TECHNICAL NOTE

File Ref: MA/PZ/P20-2187/05TN

Subject: Bacon Family – Deadline 3 Response

Figure 2.1 – Site Context

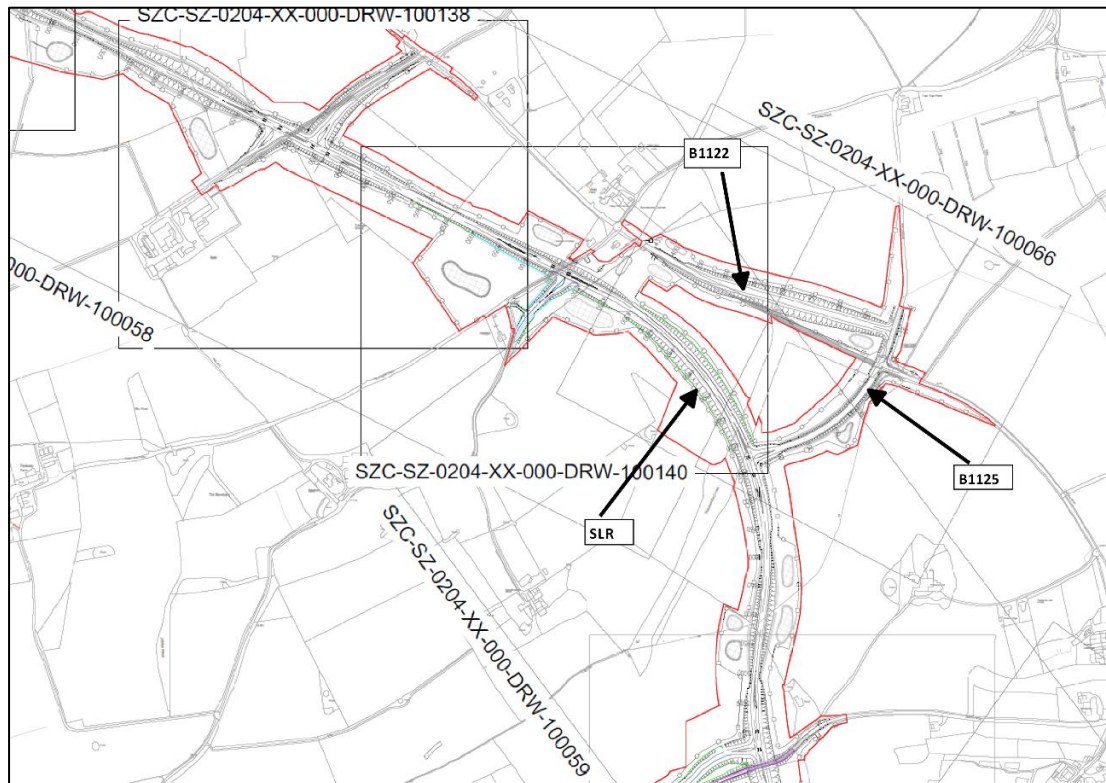
- 2.1 Figure 2.1 highlights the works proposed by the Applicant and the interface of the SLR, B1122 and B1125. Our Client's land, directly north of the B1122, is required to deliver a diversion of

the B1122 changing the current priority with the B1125 connecting direct to the SLR with a ghost island right turn lane junction arrangement.

the vicinity of our Client's land the B1122/B1125 junction (as currently proposed by the Applicant) should not give priority to the B1125.

Figure 3.6 – Alternative route (with no direct B1125/SLR connection)

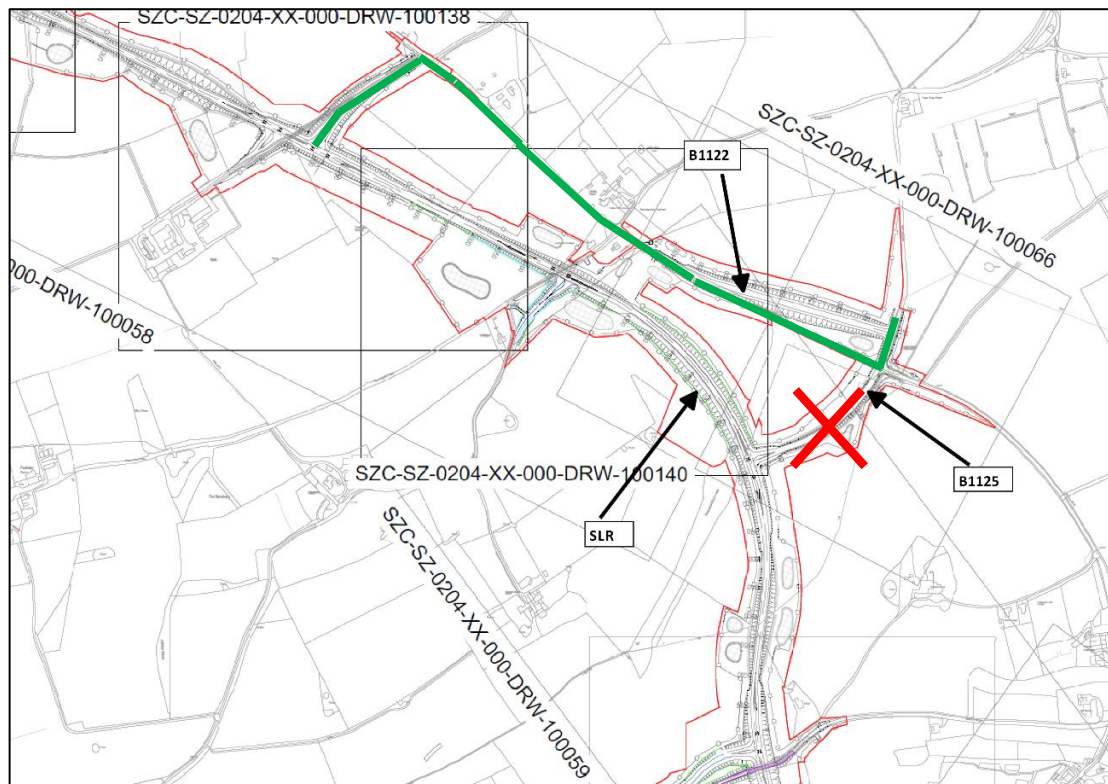
- 3.5 To further discourage use of the B1125 we suggest there is also an argument that the B1125 should not link with the SLR at all and should terminate at the B1122 (as is currently the case).
- 3.6 Traffic heading southwards along the B1125 could then join the B1122 which in turn would lead to the SLR at the junction arrangement which is proposed to the West. This would result in a less direct link between the A12 and SLR (via the B1125) and make the route less attractive than the current scheme, and could potentially minimise the land-take if the B1122 were to follow its existing alignment.
